SUNRAY SHORES WATER DISTRICT SUNRAY SHORES C#1 PUMP STATION, STORAGE AND TRANSMISSION MAIN BELMONT, NEW HAMPSHIRE

ADDENDUM #1

DATE:	JULY 29, 2024
TO:	PLAN HOLDERS

SUNRAY SHORES WATER DISTRICT SUNRAY SHORES C#1 PUMP STATION, STORAGE AND TRANSMISSION MAIN BELMONT, NEW HAMPSHIRE

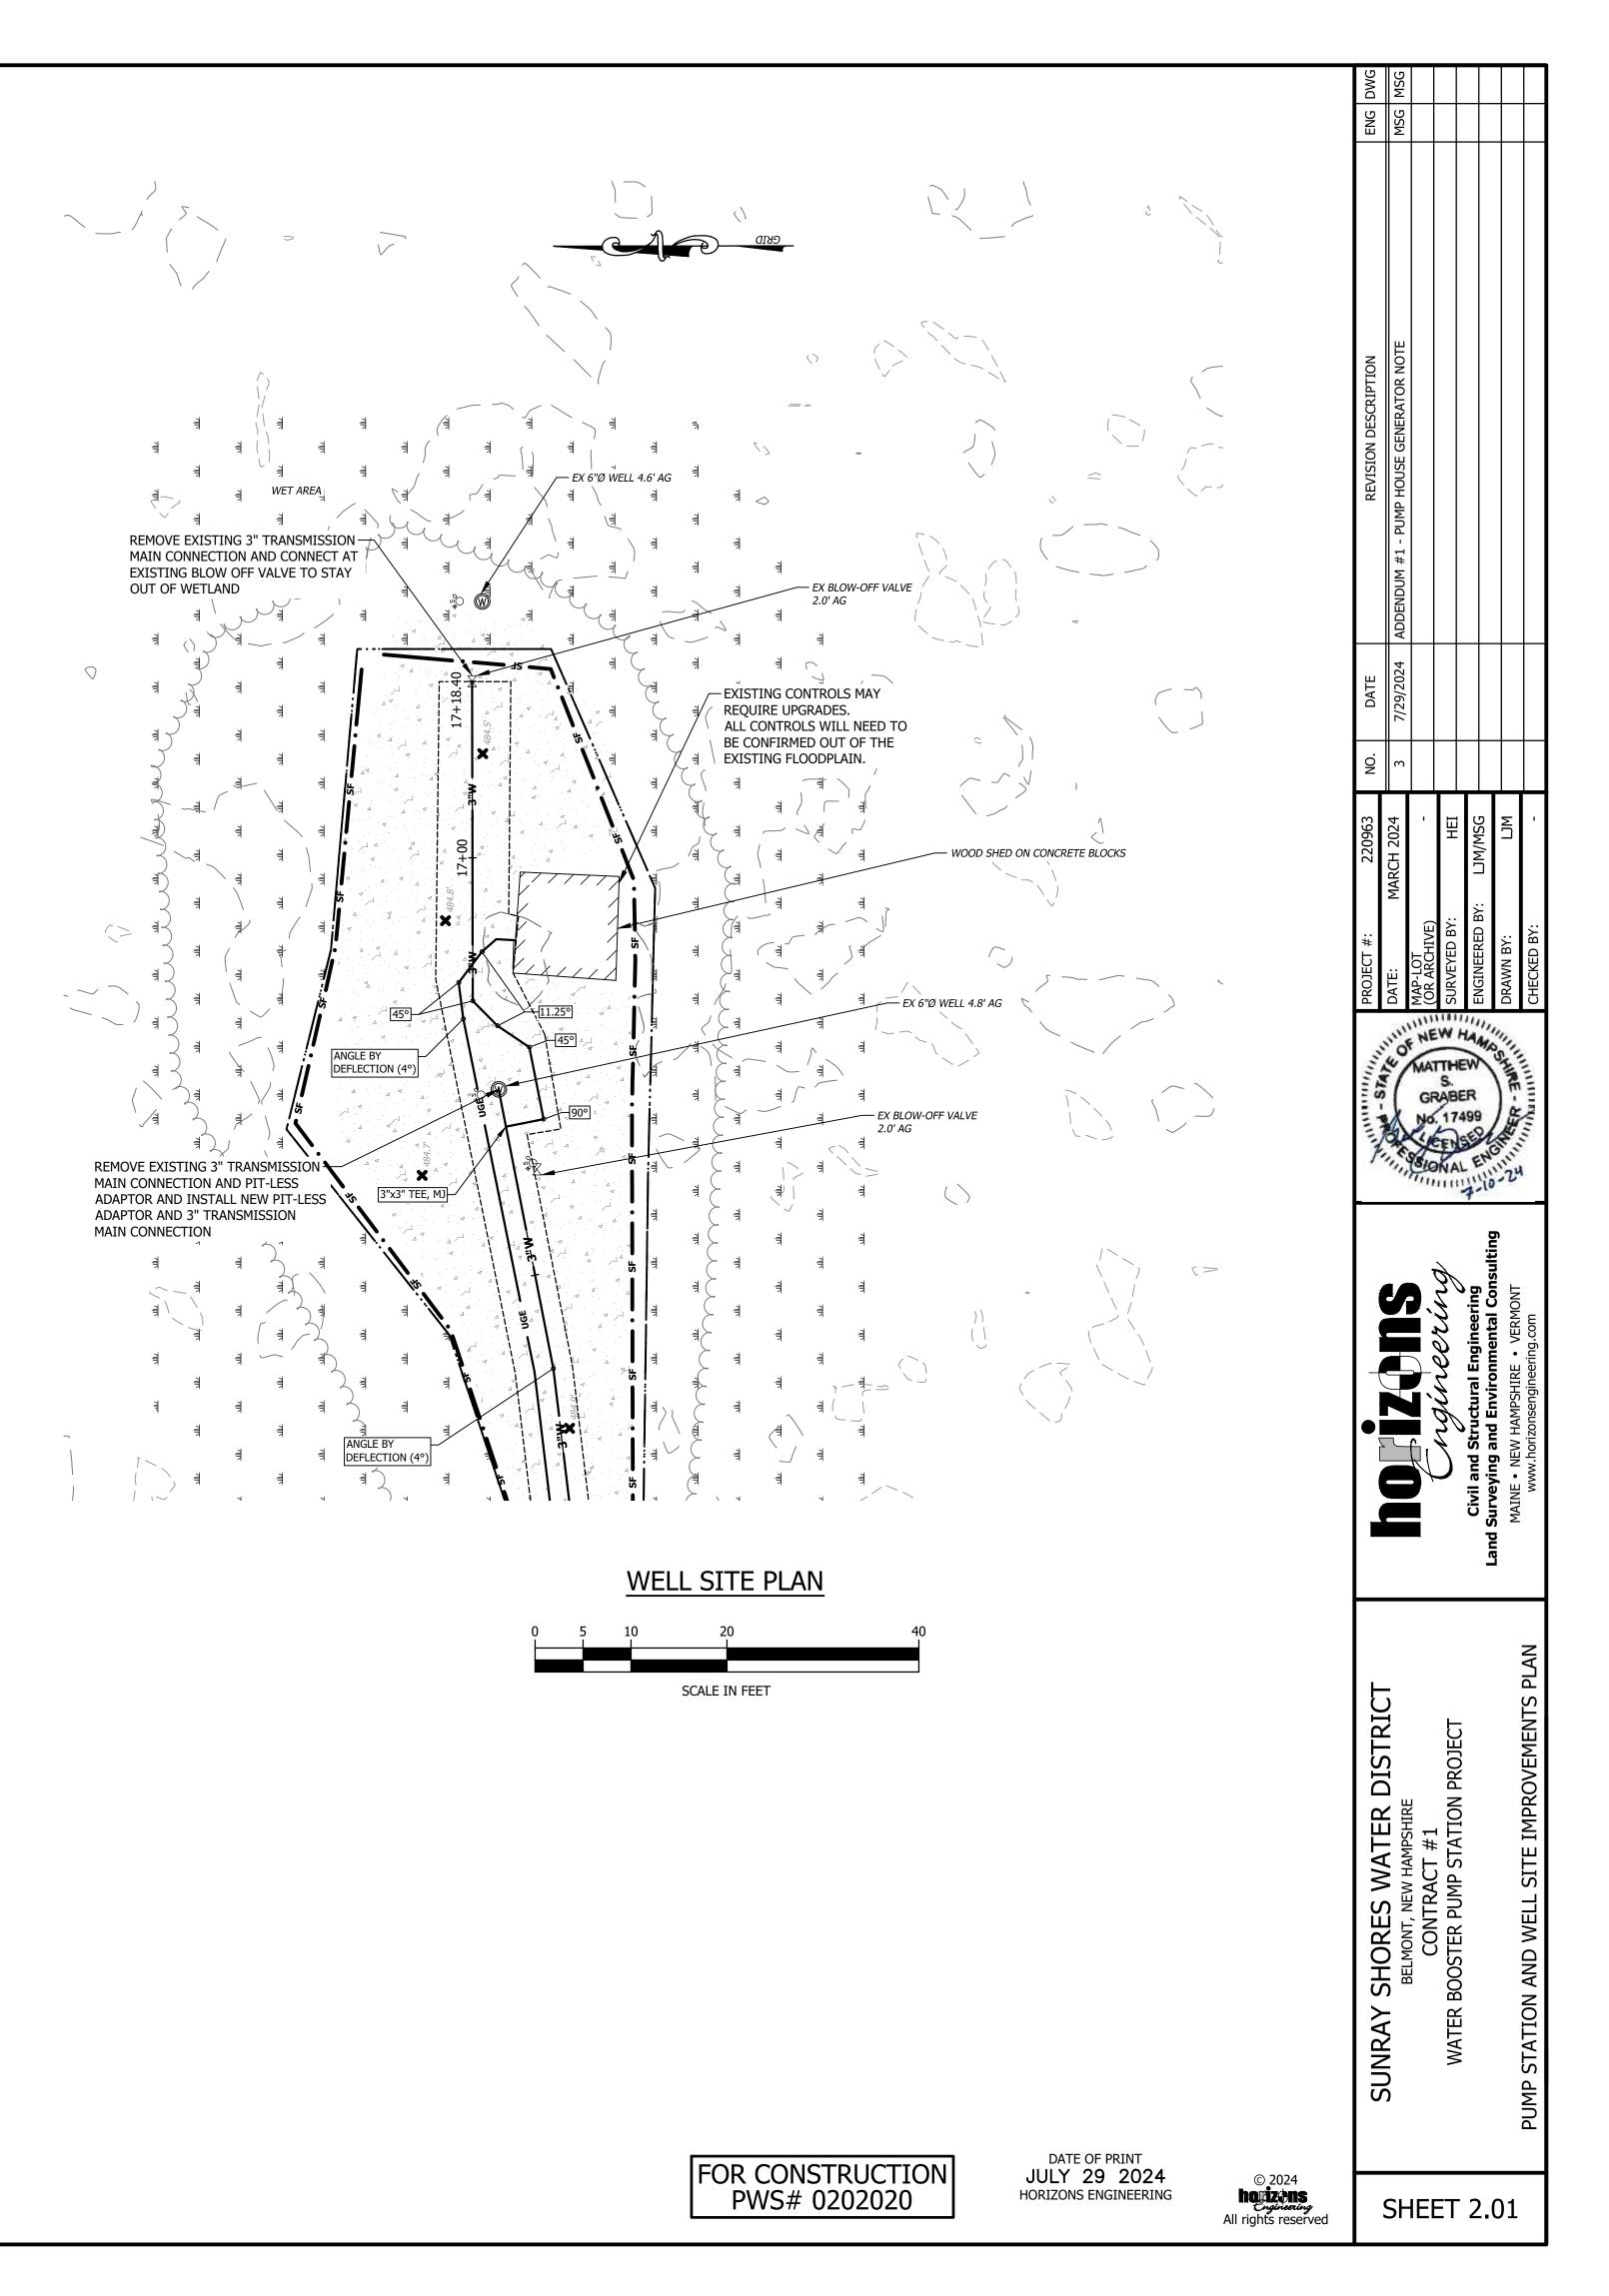
- 1. Sunray Shores Water District Contract #1 Civil Plan Set. Sheet 2.01 has been revised to expand on the note for the requirement of a back-up generator. Conceptual location of pedestal and propane tank are shown in the same location as previously shown. Revised call-out has been clouded and noted on the plans with a Revision 3 triangle for clarity.

- b. As noted in Item 1 of this addendum, a back-up generator will be required for this project. Shop drawings for the generator will need to be submitted to the Engineer for review and approval. Sheet 2.01 has provided a conceptual location for a generator pedestal and 500-gallon propane tank near the proposed pump house.
